UNITED STATES PATENT AND TRADEMARK OFFICE

APPLICATION NO.	FILING DATE	FIRST NAMED INVENTOR	ATTORNEY DOCKET NO.	CONFIRMATION NO.
09/176,580	10/21/1998	RAMESH SUNDARAM	S01.12-0460	2038

Office Action Summary

DETAILED ACTION

attachment #1

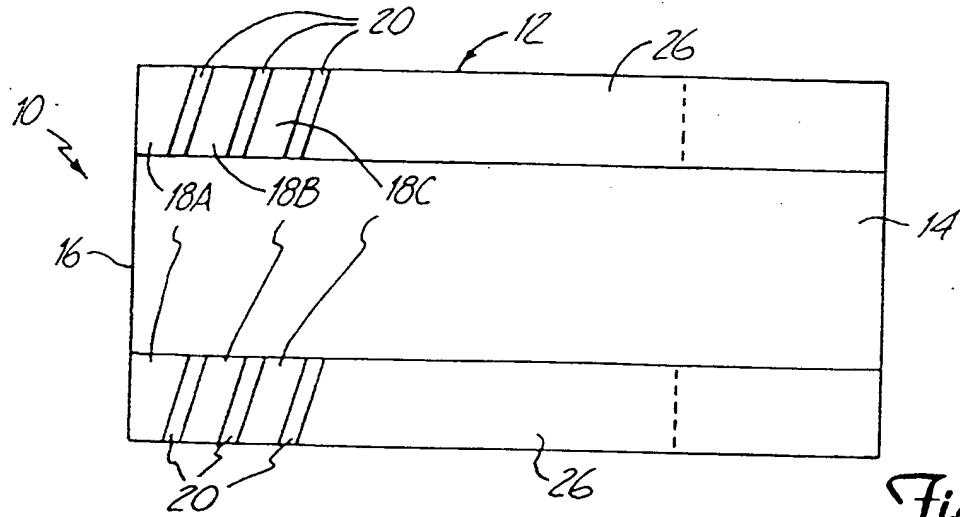
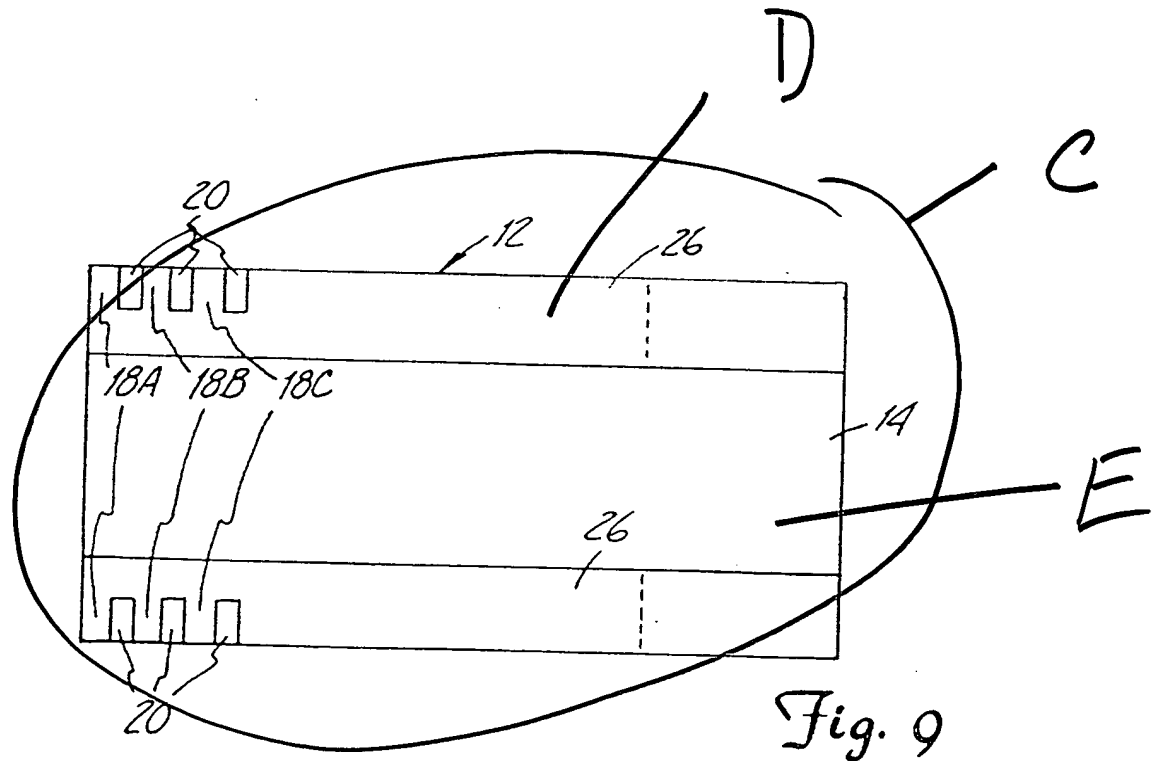
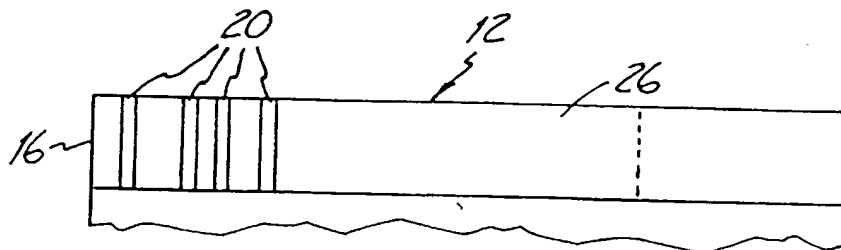
Boutaghou discloses in Figs. 1-4 and 13 a device/ glide test system having a thermal asperity sensor comprising a slider body 12 having a leading edge A, trailing edge, a contoured (having rails) disc facing surface C. The surface C has a raised bearing surface D (26) elevated from a recessed bearing surface E. The device also has transducers (plurality of magnetoresistive sensors/ MR) 18 spaced apart along the length of rails (elevated/ raised bearing surface) 26 of an air bearing surface 14 ABS (col. 6, lines 6-7 and Fig. 1). Each transducer has layers, thus, constituting a thin (having thickness/ height) flat (col. 7, line 20) asperity contacting surface (length) oriented along the ABS. As shown in Fig. 1, the transducers are oriented along (portion extending) the ABS. Inherently, the thickness of the transducer is forming a contour profile of the contoured disc facing surface and is intersecting (contacting) with its portion extending along the ABS.

For claim 29: It is inherent that the ABS must be fabricated prior to depositing the thermal transducers onto it and thus, onto the raised bearing surface of the ABS. (The numerals A- F have been added by the Examiner, see **attachment to the Office Action**).
